**SUNDRY NOTICES AND REPORTS ON WELLS**  
*Do not use this form for proposals to drill or to re-enter an  
abandoned well. Use form 3160-3 (APD) for such proposals.*

5. Lease Serial No. NM-074937
6. If Indian, Allottee or Tribe Name
7. If Unit or CA/Agreement, Name and/or No
8. Well Name and No. Hydrus 10 Federal No. 8
9. API Well No. 30-015-36546
10. Field and Pool, or Exploratory Area Loco Hills; Glorieta-Yeso
11. County or Parish, State Eddy County, NM

For better well spacing and reservoir drainage, Cimarex proposes to move the Hydrus 10 Federal No. 8 as shown below.

WELL LOCATION AND ACREAGE DEDICATION PLAT

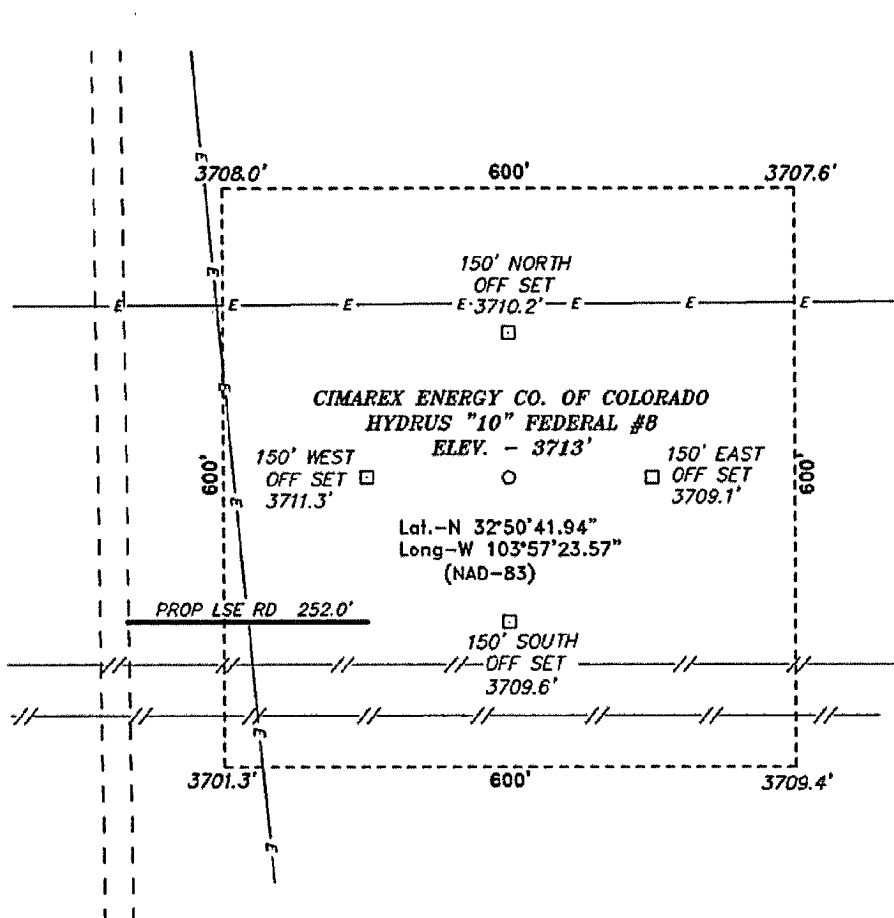
Previous Location

10-17S-30E  
710 FSL & 1650 FEL  
Eddy County, NM

New Location

10-17S-30E  
1175 FSL & 1650 FEL  
Eddy County, NM

No ROW required for the access road to this location. Please see attached plats.

Figure 1 – Cross Sections and Plans For Typical Road Sections

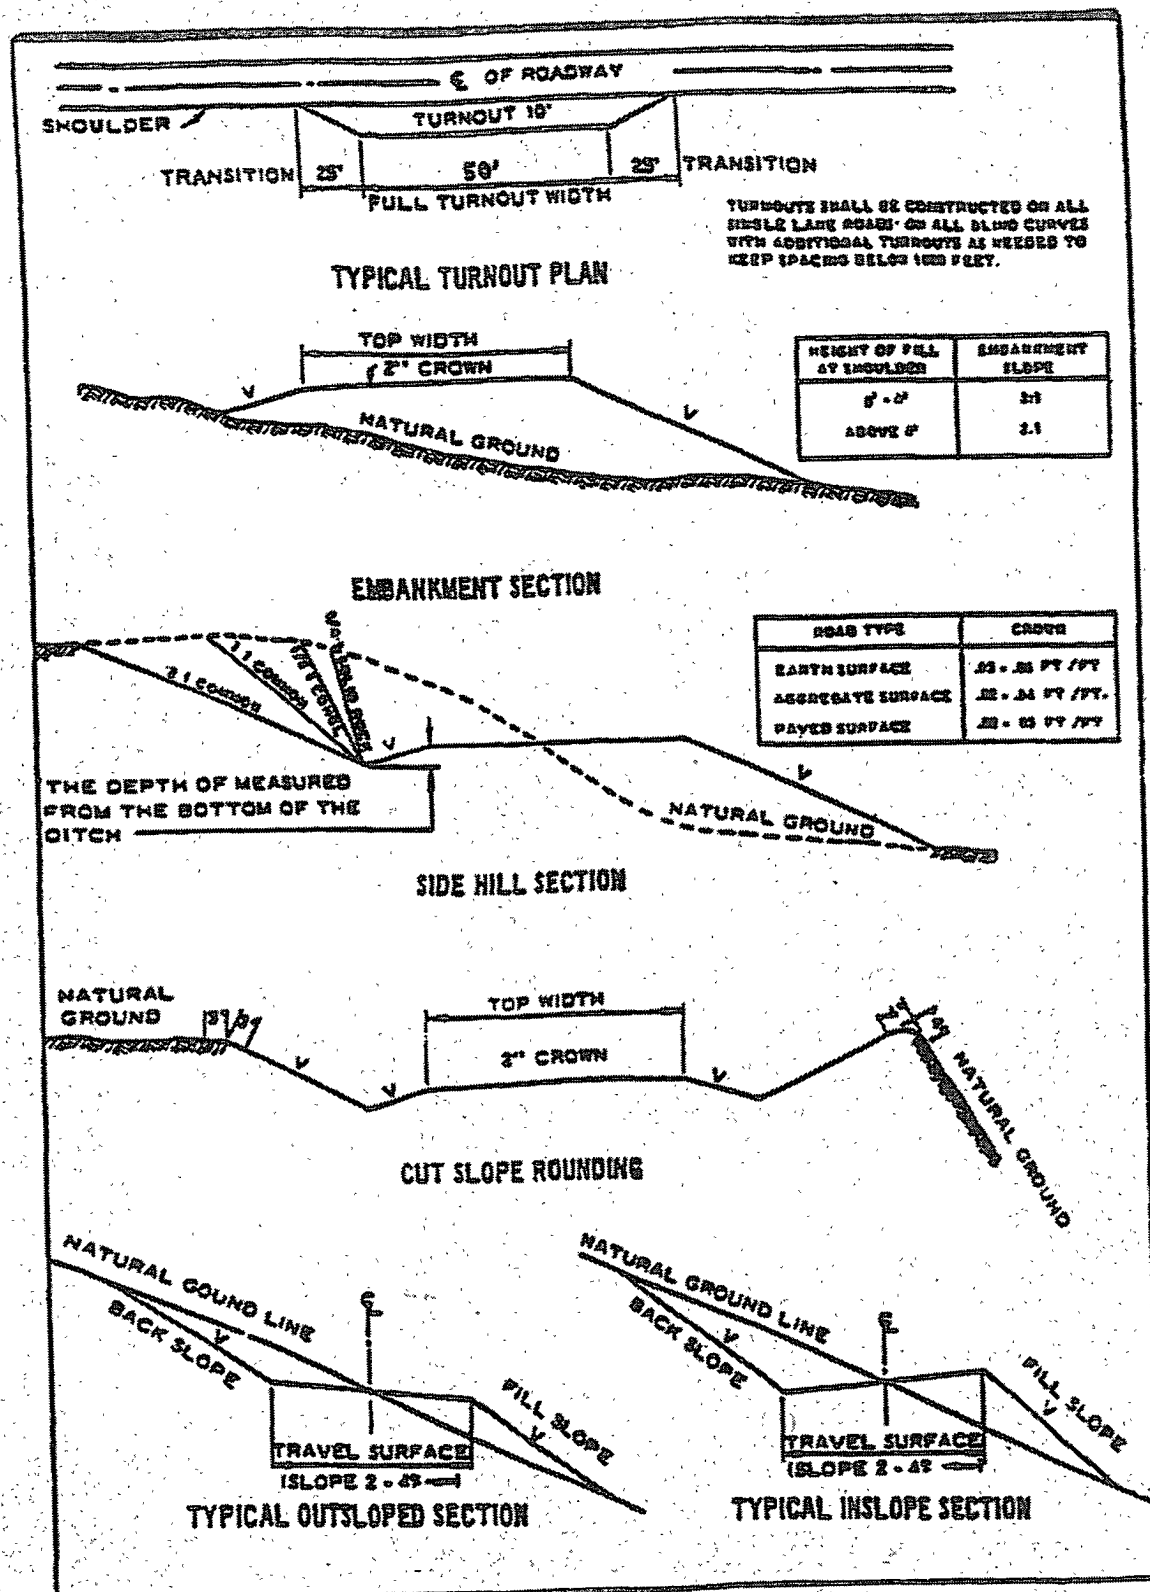
Crowning shall be done on the access road driving surface. The road crown shall have a grade of approximately 2% (i.e., a 1" crown on a 14' wide road). The road shall conform to Figure 1; cross section and plans for typical road construction.
